North Transfer Station Stakeholder Group Compendium

Chapter 4: Workshop 1

Workshop 1: Sept. 14, 2010

North Transfer Station
Stakeholder Workshop #1 Summary
Sept. 14, 2010
Institute for Systems Biology • 5 to 8 PM

CONCEPT 4 BUFFER STATUS QUO

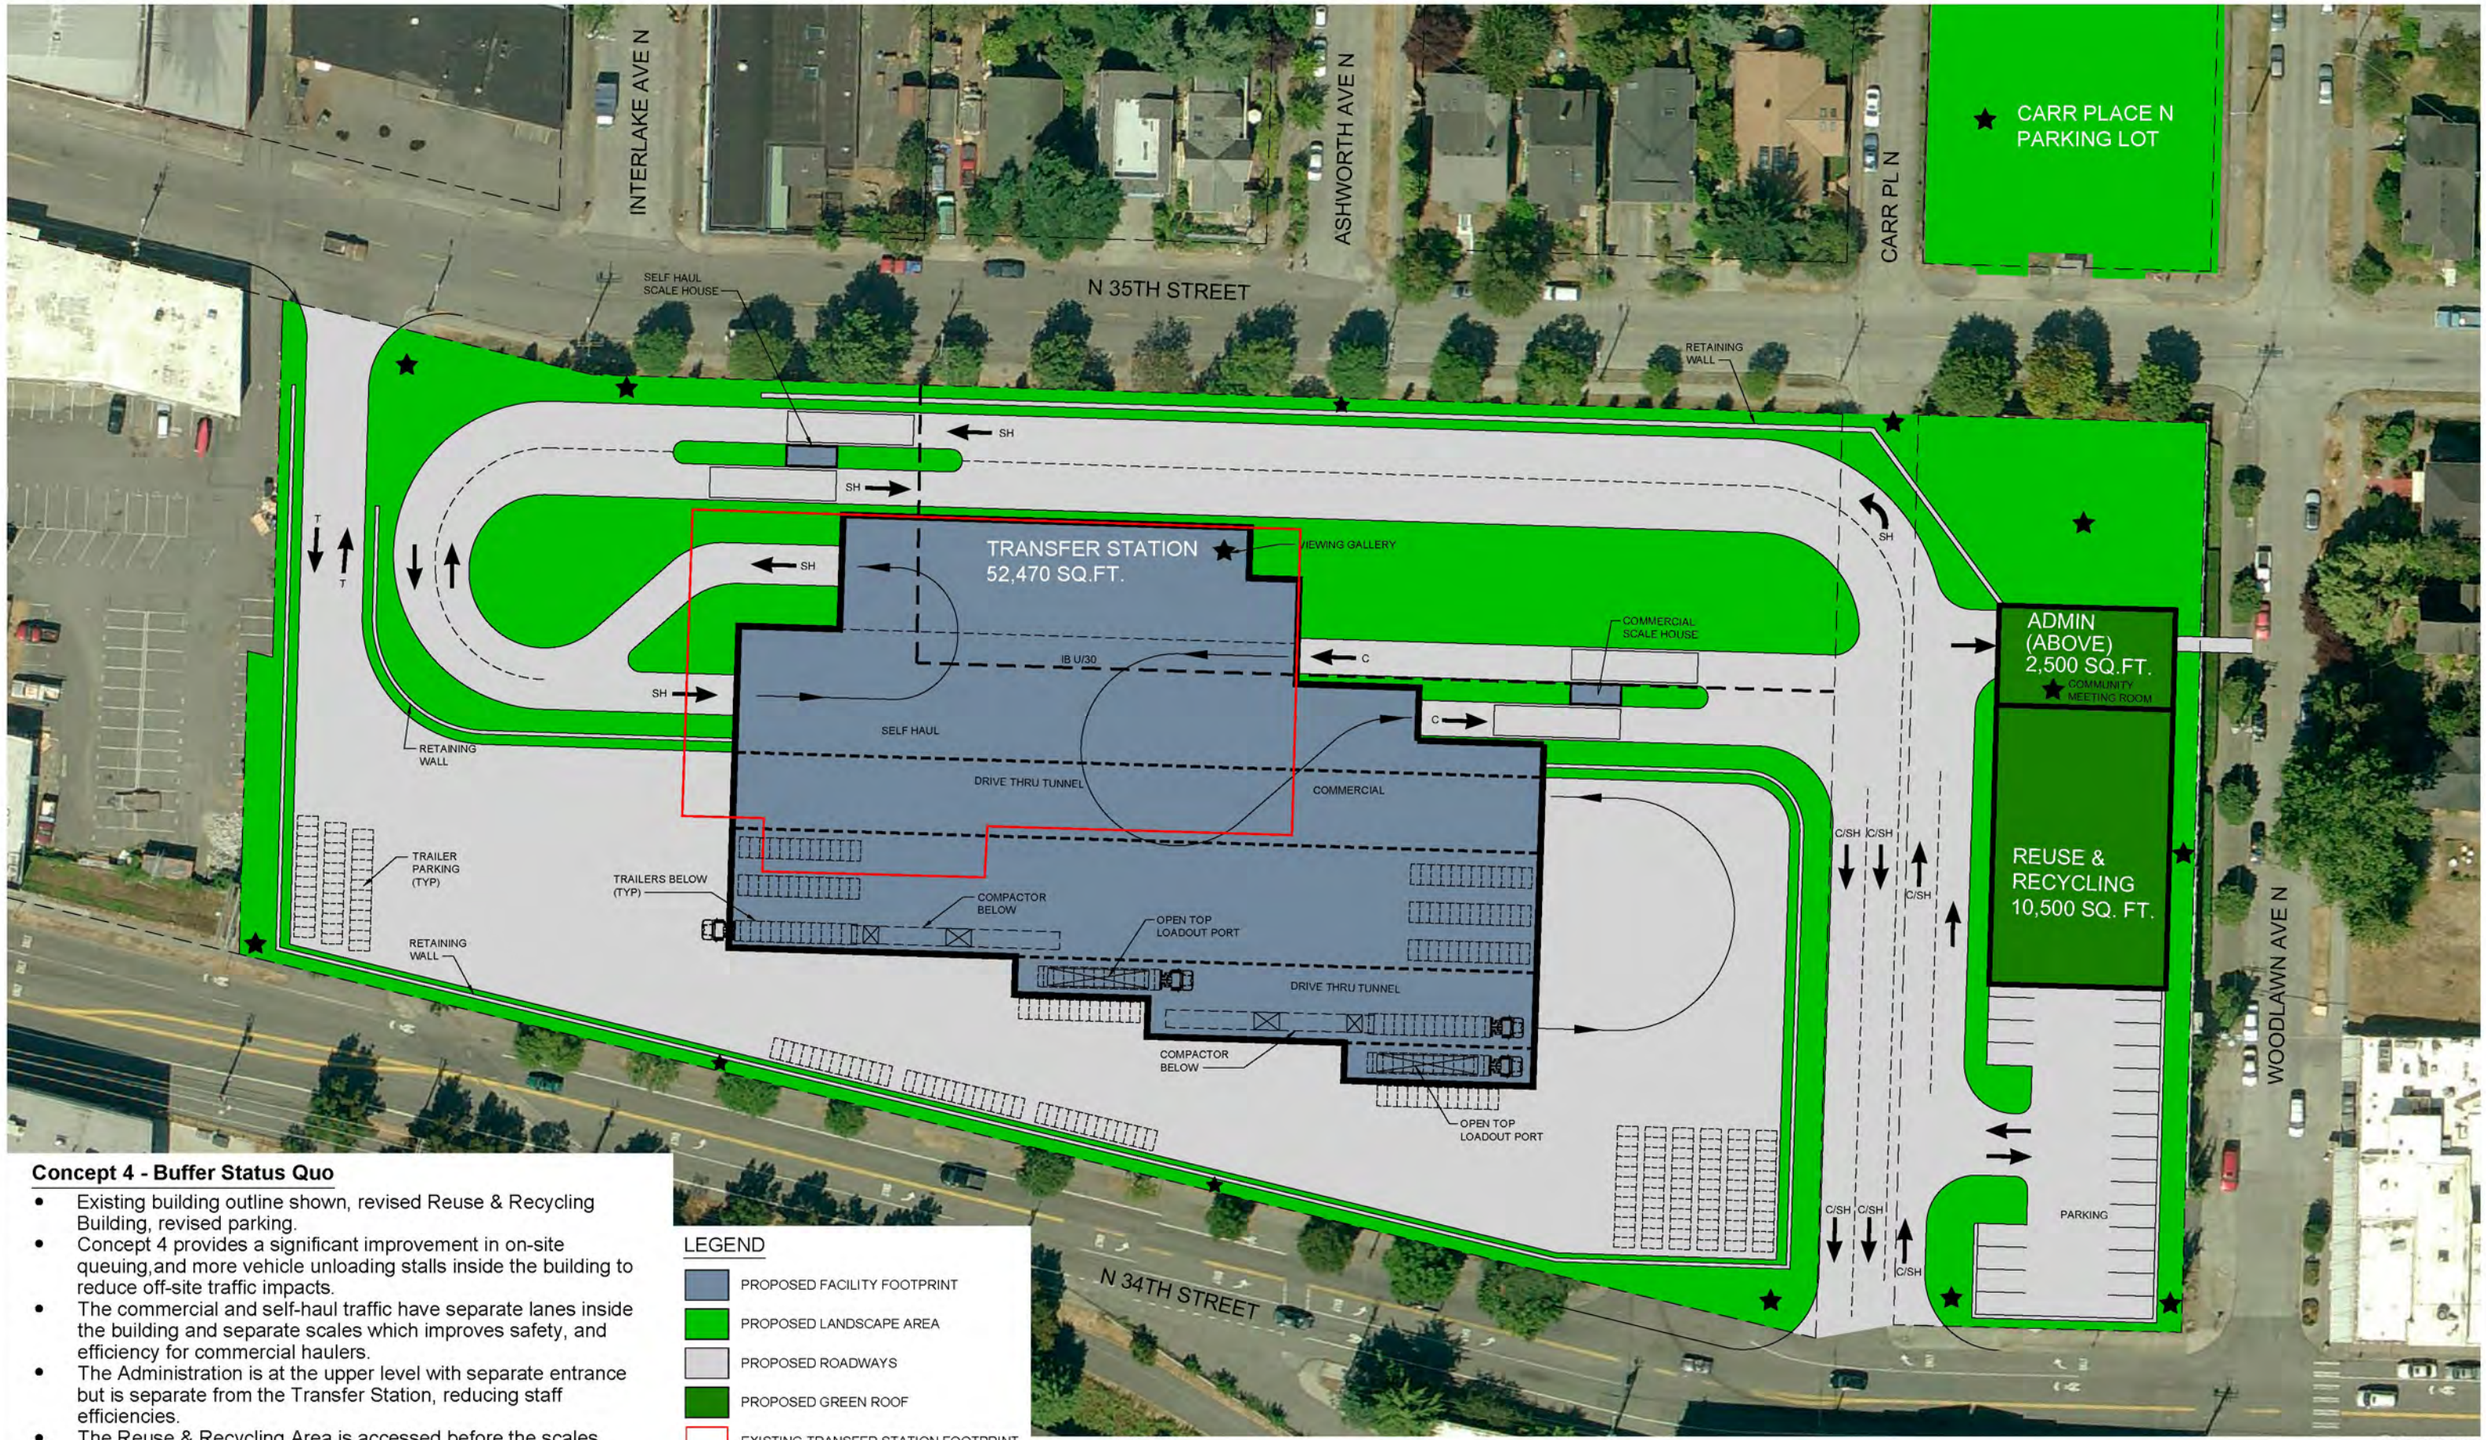
Concept 4 - Buffer Status Quo

(S) Why not have self haul and commercial haul take the same route and both drive through building? More efficient use of floor space.
(S) Pit for pick up size dump truck to dump in rather than on tipping floor

(S) Separate lane for self haulers with dump truck capability?
(S) This concept proposes 9400ft^2 for recycling/reuse. Is this adequate? Why propose 11,330 ft^2 in other options?

(S) Green space at the northeast corner with parking below = good idea!
(S) How important is it to have the administrative building connected to the station? Is it as important if Carr Place is closed?

(S) Why not extend building farther south? Do you gain efficiencies in trailer/cargo storage and tipping floor internalizing the open circulation south of the building?

(S) There seems to be a lot of unused space in the southeast corner of the transfer station site. Why couldn't trucks/containers be parked there?
(S) What's the extra cost for underground drive-through tunnel?

(S) Clean green doesn't need sorting – so why not dump clean green in an open top trailer (pit)?
(O) Not enough buffer at Woodlawn Avenue, develop entry to N. 34th Street for trailers, show buffer status quo without rezone or use of 1550.

(O) Why not stack drive lanes over turn around space?
(O) Can the building shift south to internalize the drive-though and trailer parking and pull the building out of the buffer?

(O) Can trailer exit here [southwest corner]?

CONCEPT 5
BASE SCENARIO WITH GREEN ROOF

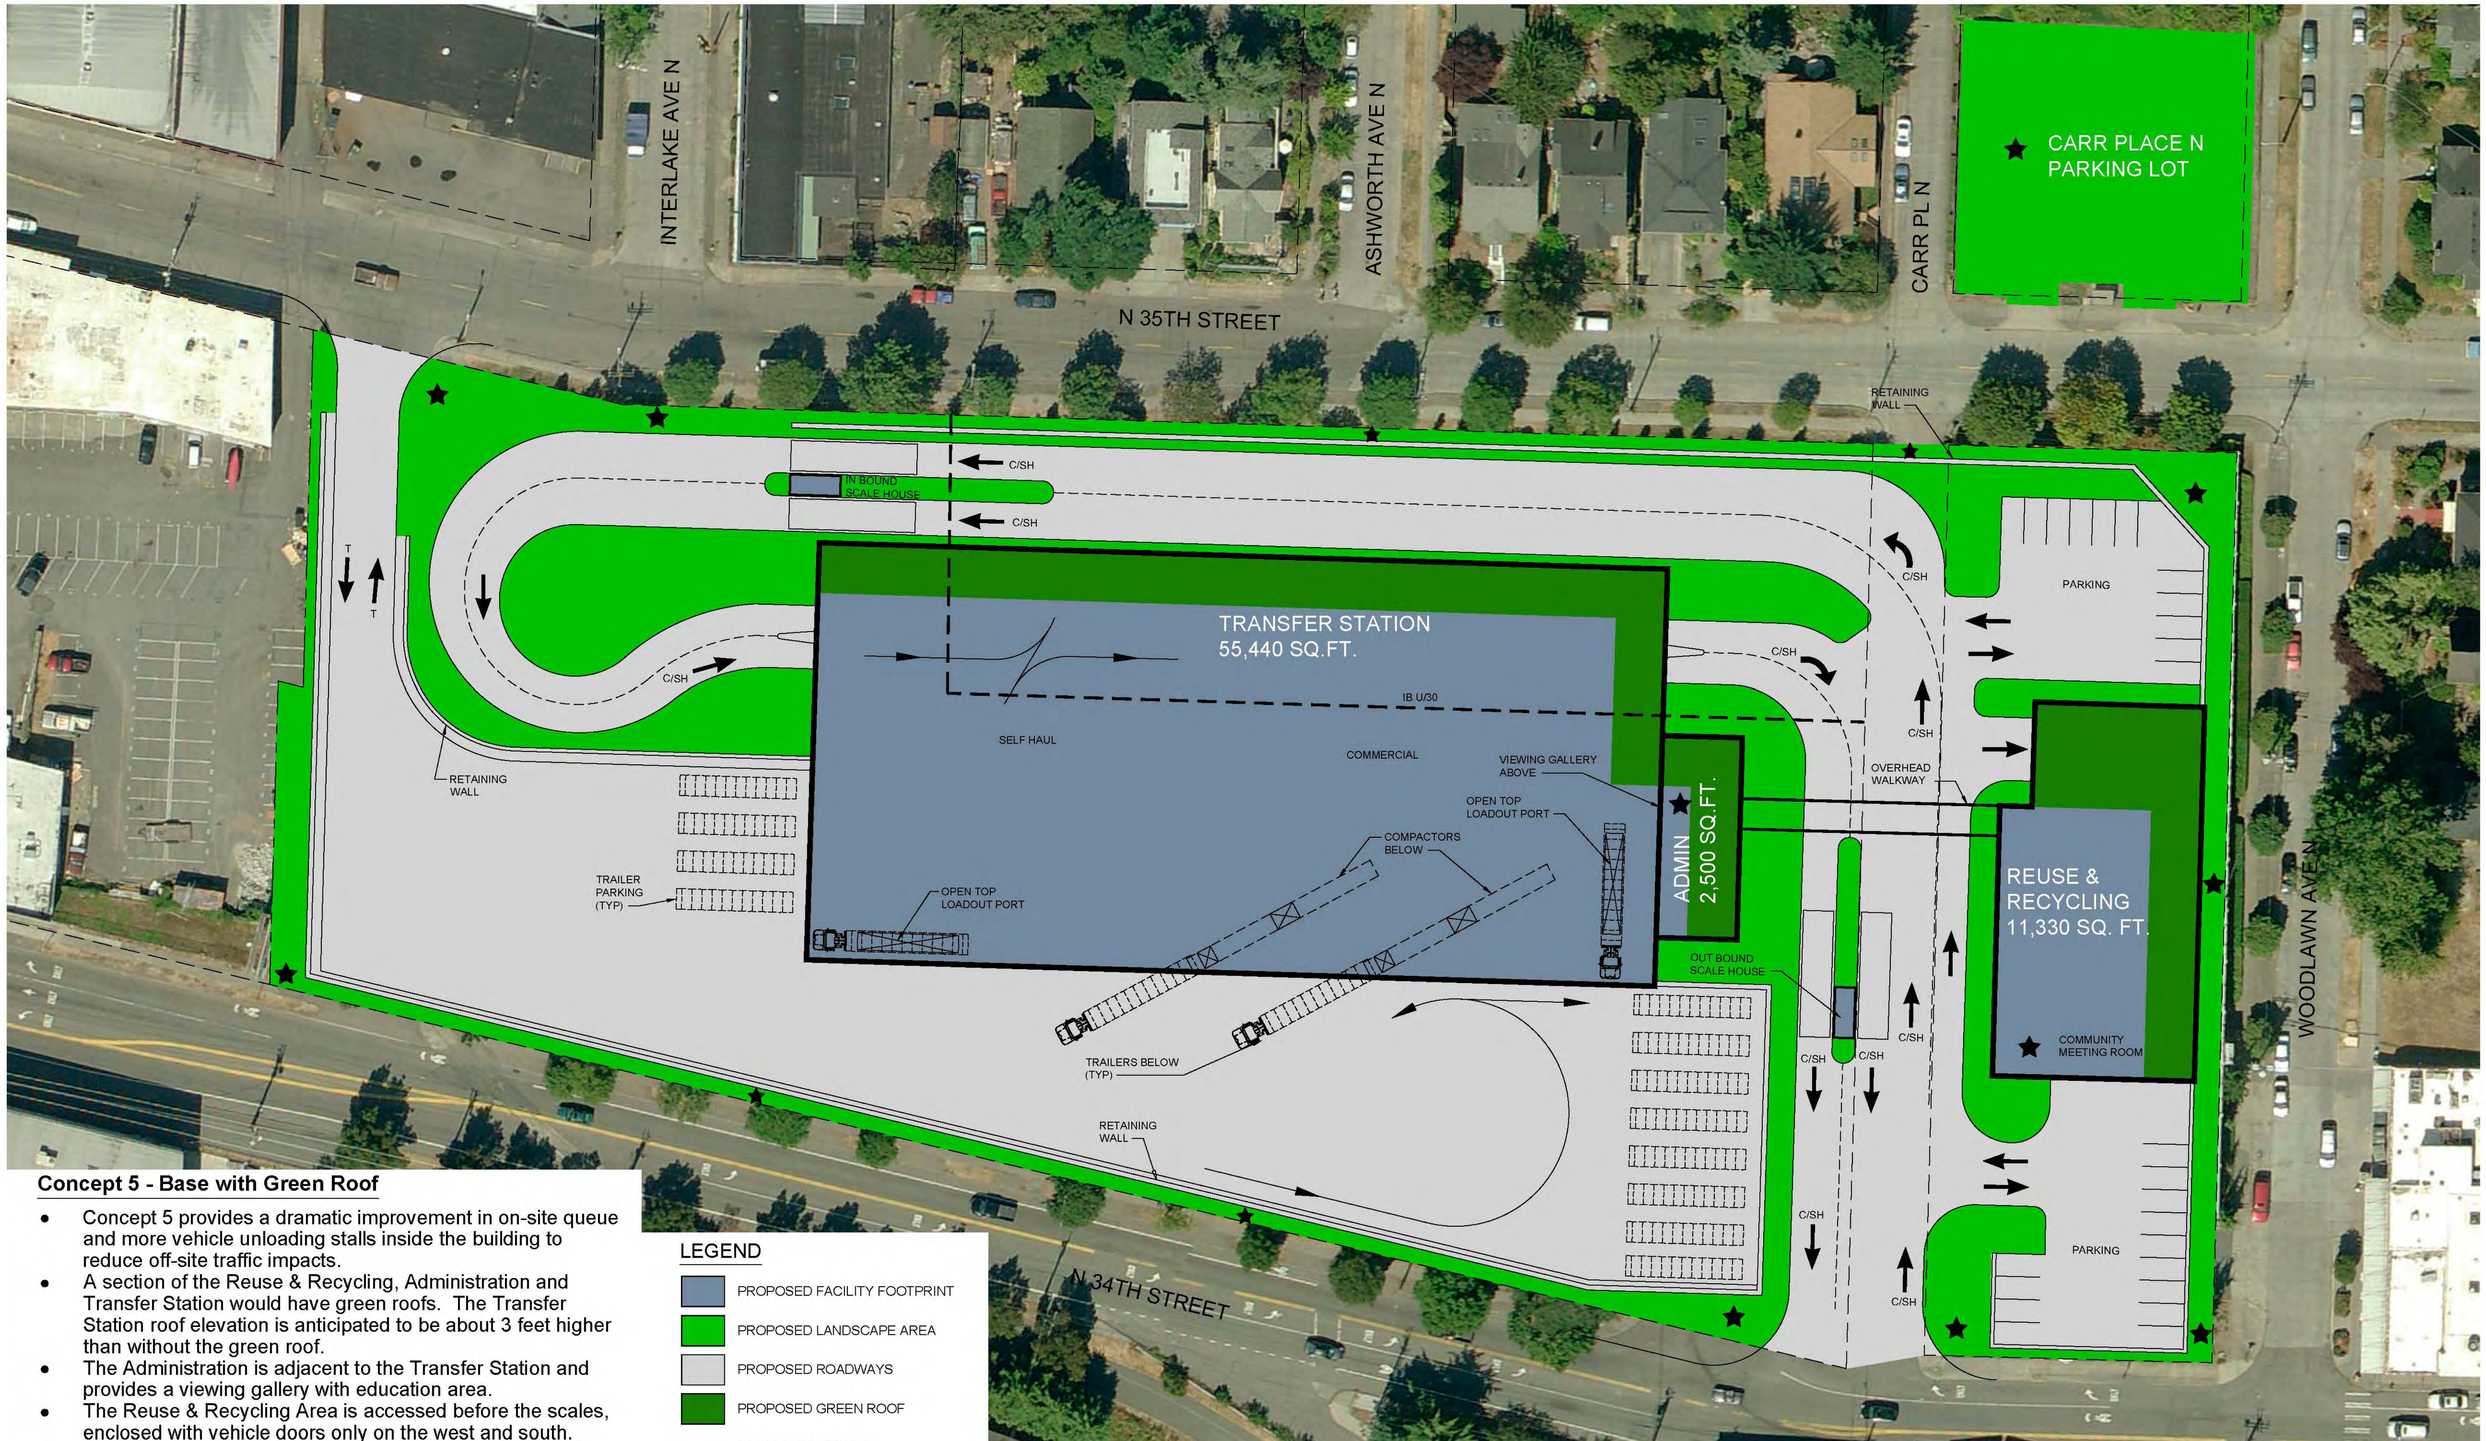
Concept 5 - Green Roof

(S) Why is the large turning space necessary after cars cross the scale? See option 2 with smaller turning space.
(O) Green roofs are a great idea; however, every city project does not seem to take them seriously despite rhetoric from city leaders.
(O) Could this [transfer station] move west?
(O) Green roof rim seems less effective.
(O) Not enough buffer at Woodlawn, too much employee parking near residential, move everything west, develop N. 34th Street entry for trailers

CONCEPT 6
WESTERN SHIFT

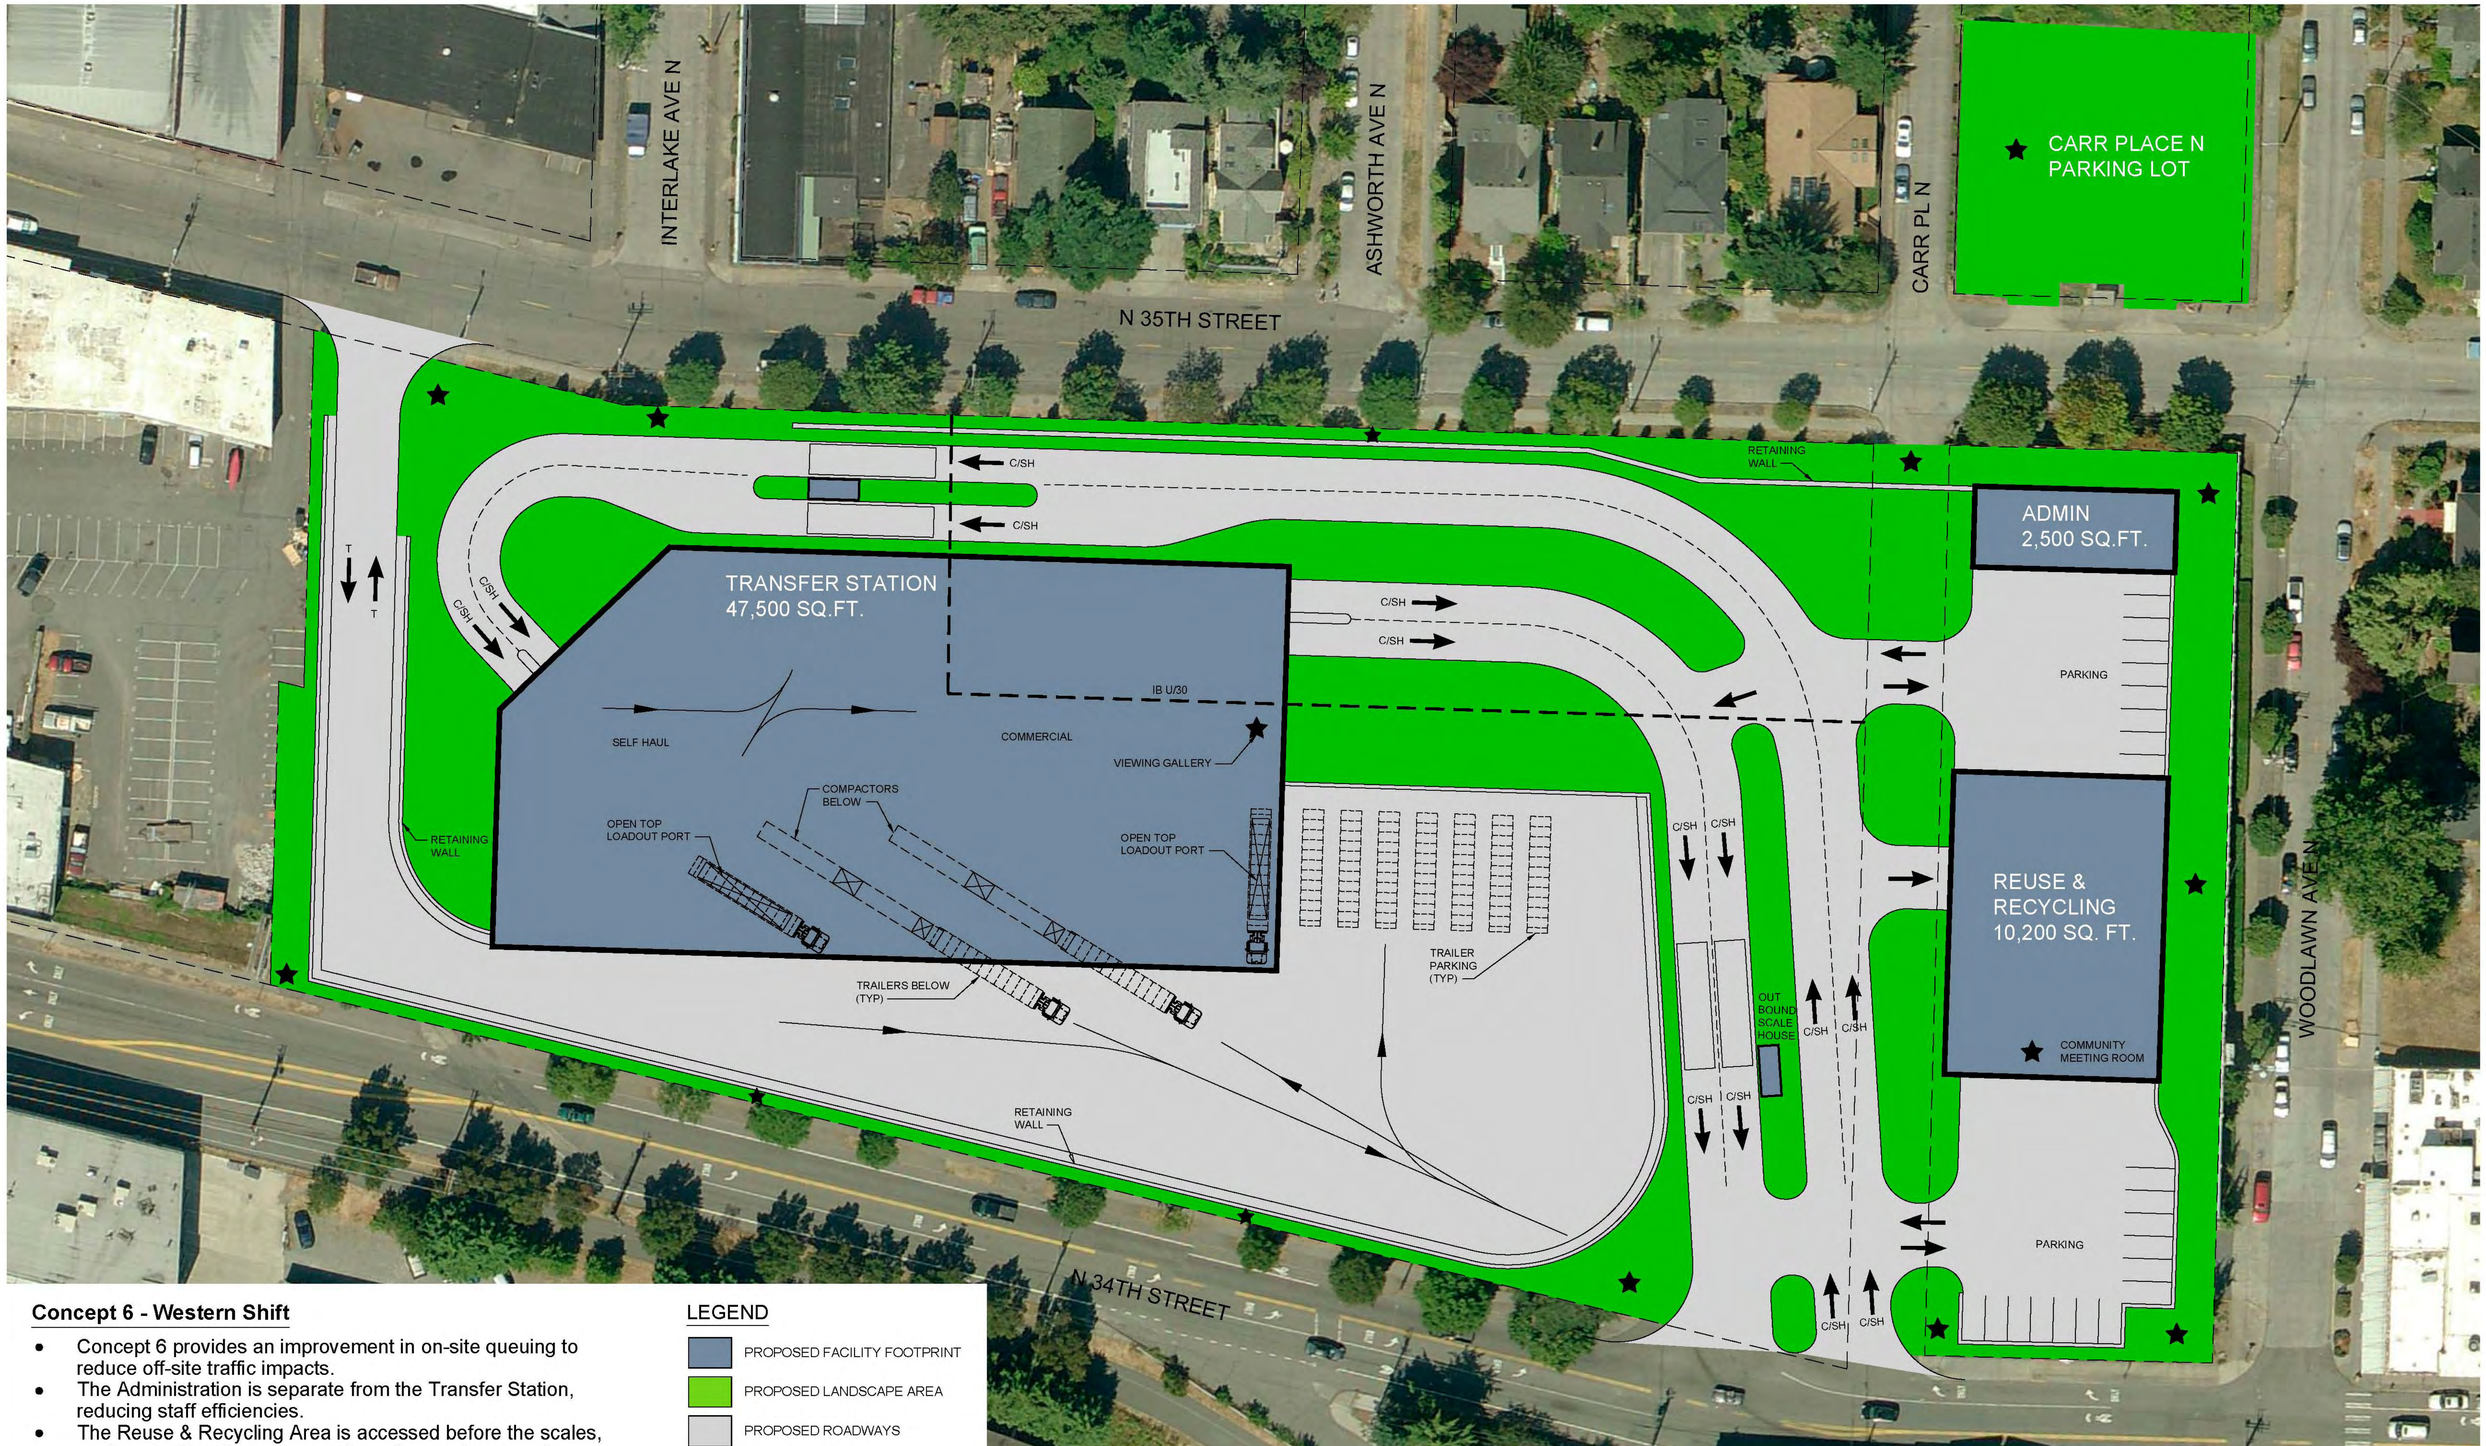
Concept 6 - Western Shift

(S) 10,200ft^2 proposed for recycling, now the range is from 9,200-11,330 – what's the difference in usage?
(S) View impacts on these homes [on N. 35th Street between Interlake Avenue and Ashworth Avenue] not just the view corridor on Ashworth Avenue.
(S) Administrative building in northeast corner seems least efficient.
(O) Have you thought of tilting the building to give more space along N. 34th Street for retail? Retail or other pedestrian friendly amenity [along N. 34th Street].
(O) Look at trucks entering from N. 34th Street.

(O) Too much trailer parking, too much employee parking, administrative building should be on top of recycling, not enough buffer at Woodlawn Avenue.
(O) How are the edges of the property considered community amenities?
(O) Why can't the entire facility shift west (including reuse and recycling)?
